SIB 11 03 21

LEAK AT OIL SUMP (PAN) SEAL

Service Information Bulletin

LEAK AT OIL SUMP (PAN) SEAL

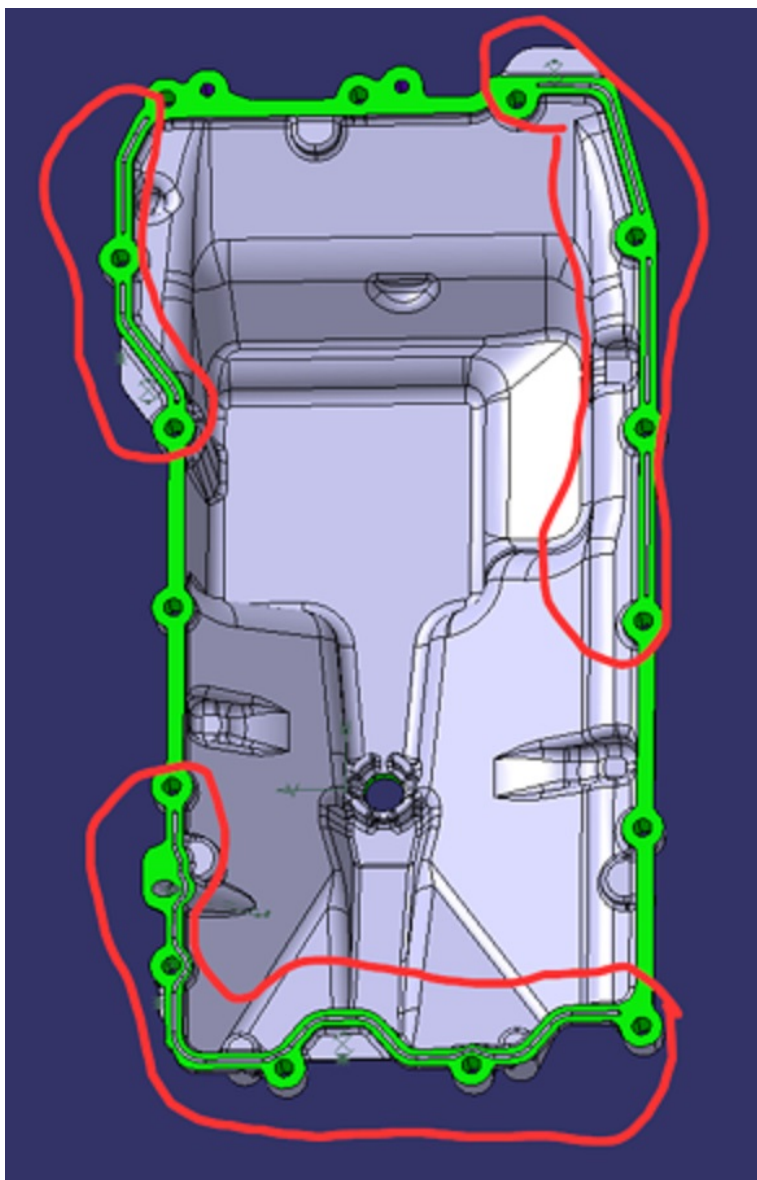
An updated version of the oil sumps will be available around March 2021 timeframe; in sections of the sealing surface, there is now a groove to take additional sealing compound, see areas marked in red in attached figure. The older version oil sumps do not have grooves for the sealing compound.

In a complaint case, always replace the older version of oil sumps which do not have grooves in the sealing surface with newer versions that do have grooves in the sealing surface.

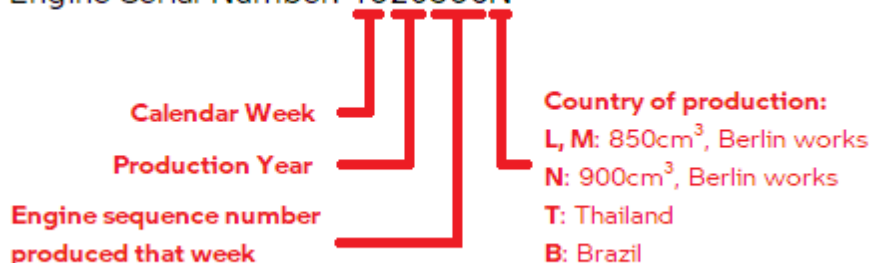
The sealing surface of the oil sump must be clean and oil-free before applying the sealing compound.

Remove adhering sealing compound residues completely from the sealing surface of the engine housing; this sealing surface must also be oil-free immediately prior to installing the oil sump.

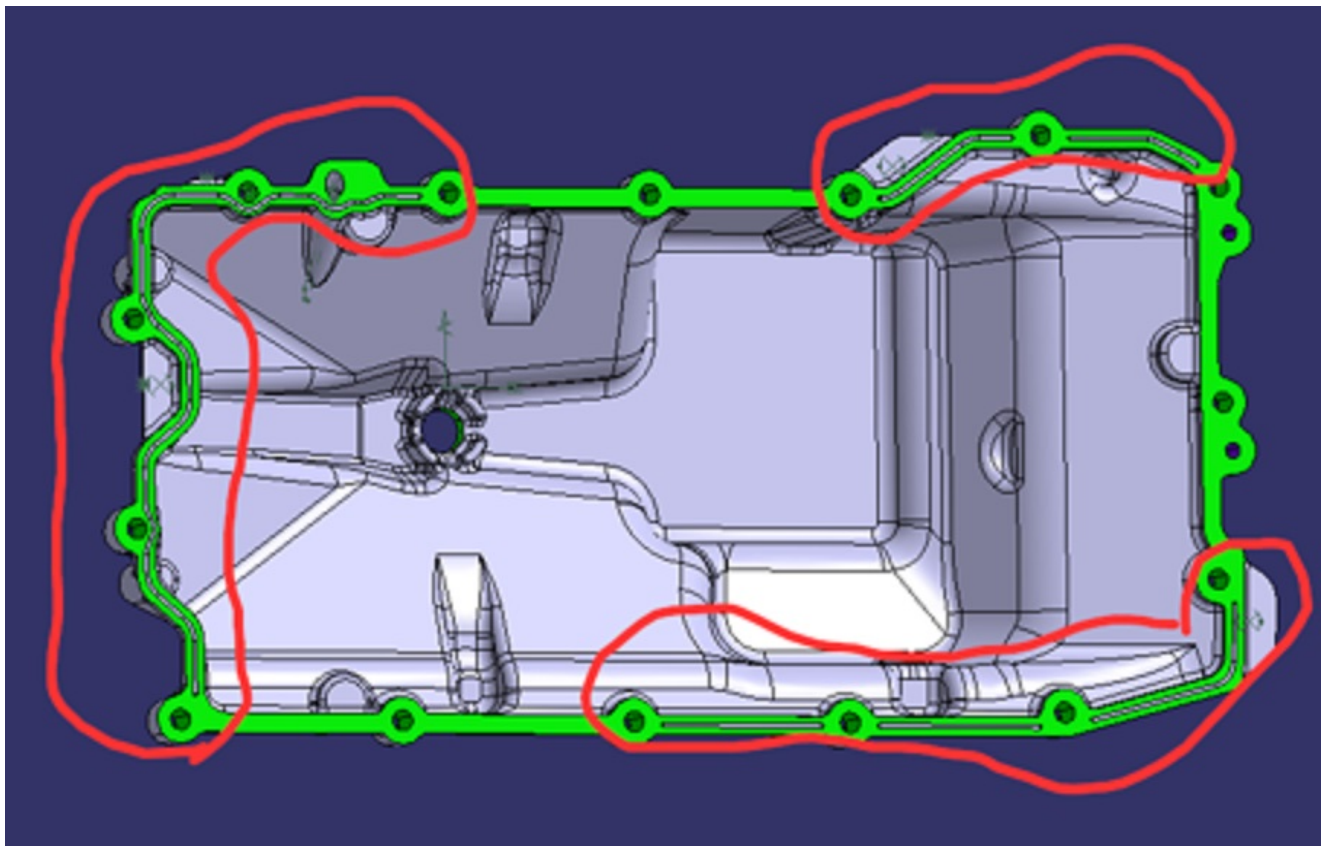
An updated version of the oil sumps will be available around March 2021 timeframe; in sections of the sealing surface, there is now a groove to take additional sealing compound, see areas marked in red in attached figure. The older version oil sumps do not have grooves for the sealing compound.

In a complaint case, always replace the older version of oil sumps which do not have grooves in the sealing surface with newer versions that do have grooves in the sealing surface.

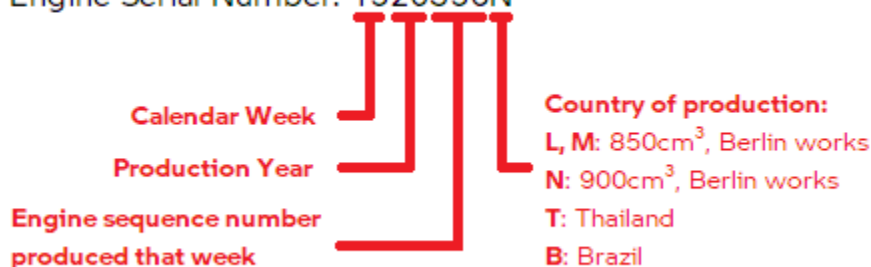
The sealing surface of the oil sump must be clean and oil-free before applying the sealing compound.

Remove adhering sealing compound residues completely from the sealing surface of the engine housing; this sealing surface must also be oil-free immediately prior to installing the oil sump.
